40/50/60 HP FourStroke Cowl Drain Valve Replacement and Top Cowl Latch Adjustment

Models Affected

Models Covered	Serial Number
40/50/60 HP FourStroke Outboard	1C050252–1C069238 may require the cowl drain replacement and the top cowl latch adjustment
	1C069239–1C076769 may require only the top cowl latch adjustment

a - Cowl drains

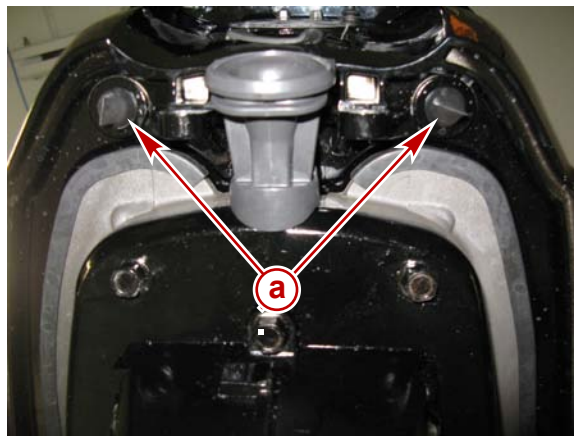
1. Remove the cowl drains (there is one located on each aft rear corner of the engine).

2. Install replacement slotted cowl drain valves.

NOTE: Lubrication may be required to install replacement drain valves. If lubrication is required, use soapy water.

- a** - Cowl latch mounting bolt holes

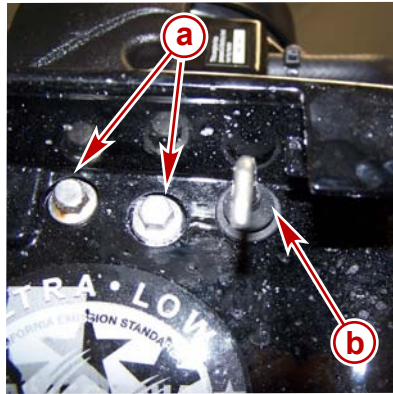
- Using an 8 mm (5/16 in.) drill, enlarge the two latch mounting bolt holes.

NOTE: Care must be taken when drilling out the mounting holes due to fuel system components behind the drilling location.

- Use black touch-up paint to cover the aluminum exposed during the drilling process.
- Allow the touch-up paint to dry for 30 minutes.
- Reinstall and reposition the cowl latch assembly. The latch should be positioned at the bottom of the newly enlarged holes. The latch bolts should then be reinstalled.

NOTE: It may be necessary to loosen and retighten the latch mounting bolts to obtain a proper cowl fit.
